Contract #: 04-0120F4Cty: SF/ALA Rte: 80 PM: 13.2/13.9File #: 69.25B**QUALITY ASSURANCE -- NON-CONFORMANCE REPORT****Location:** Changxing Island, Shanghai, PRC**Report No:** NCR-000138**Prime Contractor:** American Bridge/Fluor Enterprises, a JV**Date:** 28-May-2008**Submitting Contractor:** Zhenhua Port Machinery Company, Ltd (ZPMC), Changxing Island**NCR #:** ZPMC-0132**Type of problem:**

Job Name: SAS Superstructure

Subject: NCR No. ZPMC-0132

Reference Description: Unapproved Mechanical Straightening

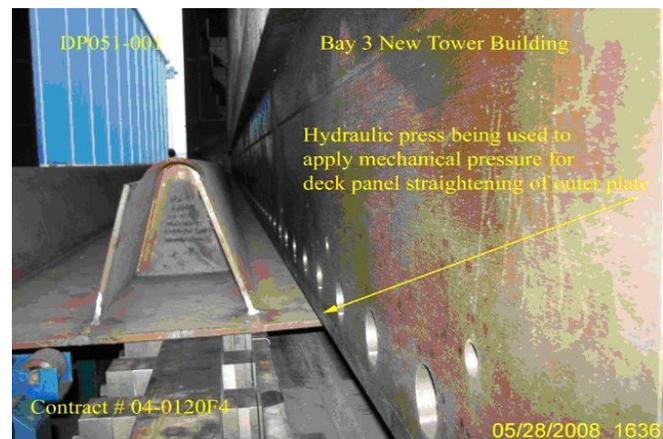
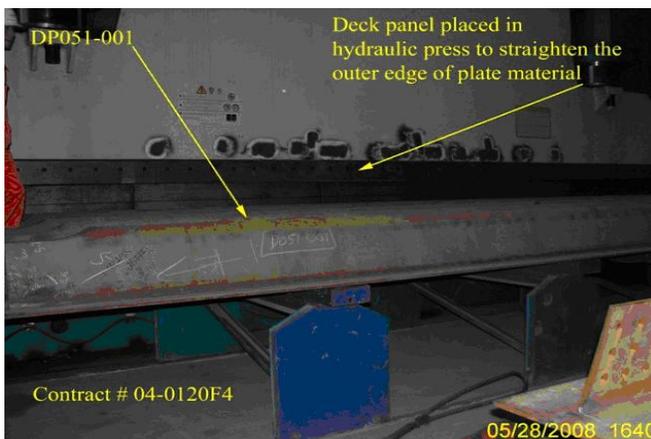
The Contractor performed straightening of members using means that have not been approved by the Engineer.

The Contractor placed the deck panel DP051-001 into a hydraulic press plate bender and applied pressure to straighten the outer edge of the panel. This straightening of the deck panel plate was not approved by the Engineer as required by AWS D1.5, Section 3.7.3 which states, "Members distorted by welding shall be straightened by mechanical means or by carefully supervised application of a limited amount of localized heat as approved by the Engineer."

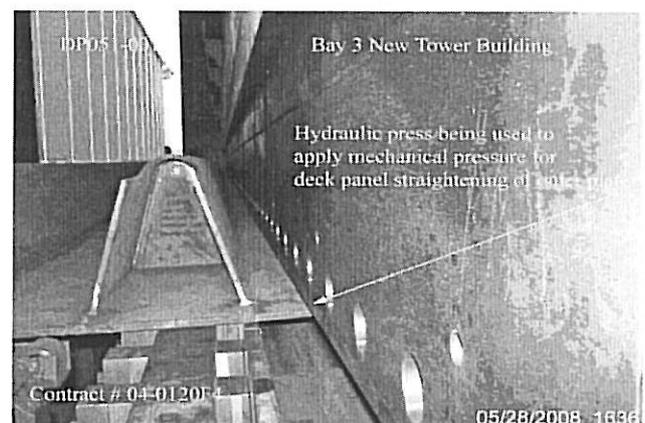
The Contractor performed straightening of members using means that have not been approved by the Engineer.

The Contractor placed the deck panel DP051-001 into a hydraulic press plate bender and applied pressure to straighten the outer edge of the panel. This straightening of the deck panel plate was not approved by the Engineer as required by AWS D1.5, Section 3.7.3 which states, "Members distorted by welding shall be straightened by mechanical means or by carefully supervised application of a limited amount of localized heat as approved by the Engineer."

Heat Straightening Record (HSR1)

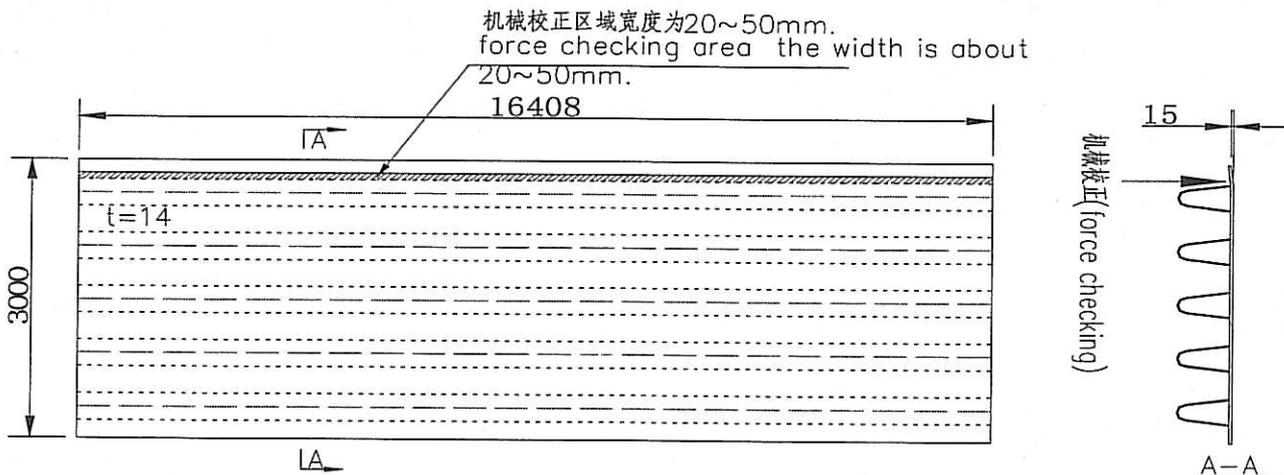
缺陷去除方法(Defect Removal Method): Mechine Straightening

注: 最大变形量约15mm.

Note: the max deformation is about 15mm.

后续NDE(Post-Removal NDE): After finishing machine straightening, the weld of the heat area shall perform NDT according to the approved shop drawing

纠正措施(Corrective Action(s)): Control current, voltage and weld speed according to relevant WPS. If necessary anti-deformation or hold down device can be added.
